XC3S1000 and XC3S1000L FPGA Errata and Deviations from Spartan-3/3L Data Sheet

DS099-E05 (v2.5) December 14, 2006

Errata Notice

Figure 2: Spartan-3 FPGA from UMC 300 mm facility with "GQ" Fabrication/Process Code Marking

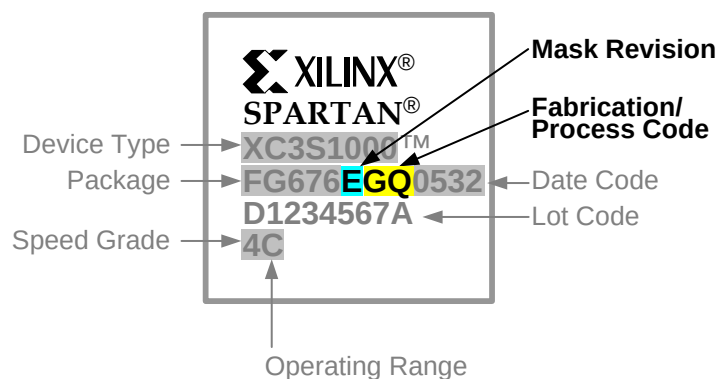
This issue only applies to those designs using the Readback feature on the XC3S1000 or XC3S1000L FPGAs shown in [Table 5](#) with a “GQ” Fabrication/Process Code marking, as shown in [Figure 2](#).

The readback feature is not available for the devices indicated in [Table 5](#).

XC3S1000 FPGAs with an “FQ” Fabrication/Process Code marking fully support the Readback feature. Similarly, XC3S1000 or XC3S1000L FPGAs with an “EGQ” Mask/Fabrication/Process Code marking and with a Date Code of “0532” or later fully support Readback.

Figure 3: Requirements when VCCINT is not the Last Supply

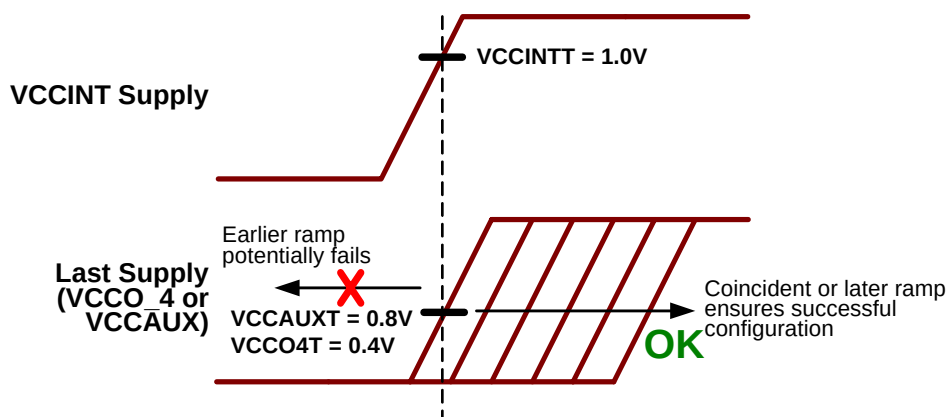
In the potentially failing condition, the VCCINT supply must be the last supply to reach its valid POR voltage and the ramp rate must be slower than 500 μ S. When the FPGA fails to configure, the INIT_B remains Low and the FPGA ignores the PROG_B program pin. Even with the worst identified power sequence, actual failures only occur on a small percentage of devices, typically measured in parts per million. The issue is more pronounced at cold temperatures.

OPTION 2: Use a power-on sequence where VCCINT is not the last supply to reach its POR threshold level.

VCCINT must reach its maximum POR threshold ($V_{CCINTT} = 1.0V$) before or coincident with VCCAUX reaching its minimum threshold ($V_{CCAUXT} = 0.8V$). This supply sequence and threshold relationship is illustrated in [Figure 3](#).

Alternatively, VCCINT must reach its maximum POR threshold ($V_{CCINTT} = 1.0V$) before or coincident with VCCO_4 supplying I/O bank 4 reaching its minimum threshold ($V_{CCO4T} = 0.4V$). This supply sequence and threshold relationship is also illustrated in [Figure 3](#).

Figure 5: Example Spartan-3 Package Markings

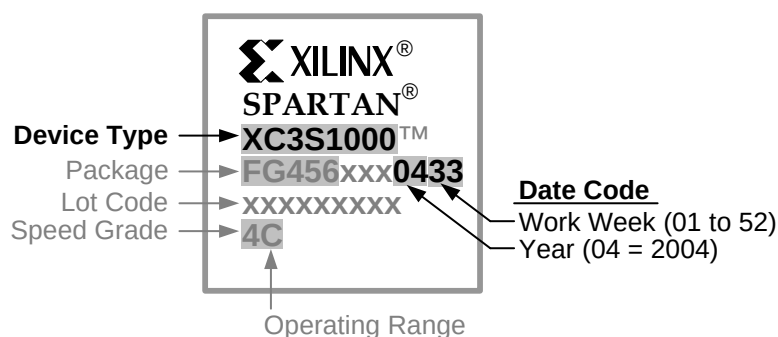
Spartan-3 block RAM internal timing is controlled by settings in the FPGA configuration bitstream. Through yield analysis, new optimal bitstream settings were identified for specific Spartan-3 device types. These new settings improve the block RAM internal timing margin, which consequently improves overall product yield and availability. **These new settings do not affect any timing in the FPGA application**, only internal timing relationships within the block RAM. The specific improved internal block RAM timing path is the relationship between the write-enable timing and the input latch-enable timing.

These new bitstream settings are now the default settings starting with Xilinx ISE 6.3i, Service Package 1, available for download from the Xilinx web site after September 13, 2004. XC3S1000 FPGAs are tested using these new bitstream settings beginning with date codes "0433", corresponding to Work Week 33 of 2004. [Figure 5](#) shows an example top marking for a Spartan-3 FPGA. The relevant fields to identify an affected device are highlighted and include the **Device Type** and the **Date Code**.

Please regenerate any Spartan-3 FPGA configuration bitstreams created using software versions prior to Xilinx ISE 6.3i development software, Service Pack 1. By updating the bitstream, the application can use any existing or future production Spartan-3 FPGA device.

Figure 6: Enable User Editing in FPGA Editor

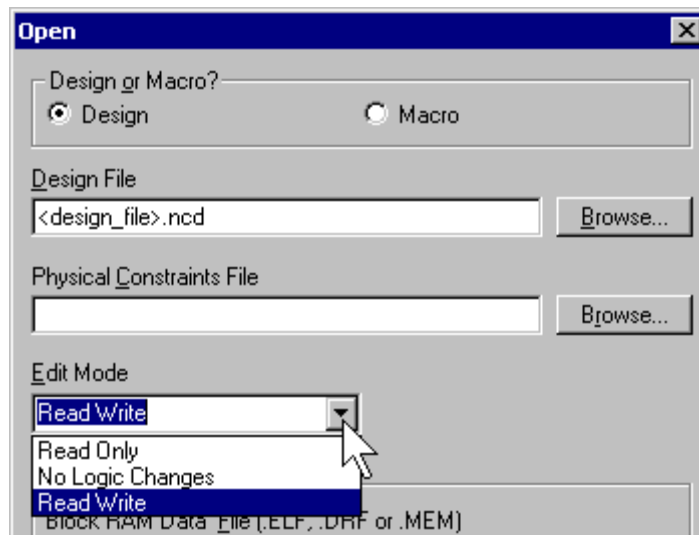
The DCM automatically compensates for process, voltage, and temperature (PVT) changes and consequently it periodically updates its delay tap settings. The rate at which the update occurs is controlled by an internal attribute called FACTORY_JF. Xilinx has identified an optimal FACTORY_JF setting value (FACTORY_JF=8080). Other settings may potentially fail to track properly over process, voltage, and temperature.

Without using the optimal settings, the DCM could potentially, with low probability, fail to assert the LOCKED output, could lose lock, or could produce erroneous clock outputs.

The new optimal settings are applied starting with Xilinx ISE 8.2i. If using an earlier version, modify the new FACTORY_JF=8080 settings on each DCM instantiated in the design. [Table 7](#) shows the best available options to update the DCM settings, depending on current design status.

- Invoke the FPGA Editor. On Windows PCs, select **Start → Xilinx ISE 6 → Accessories → FPGA Editor**.
- Select **File → Open**. Select the *.ncd file for the completed design. Set the **Edit Mode** to “Read Write” mode as shown in [Figure 6](#).
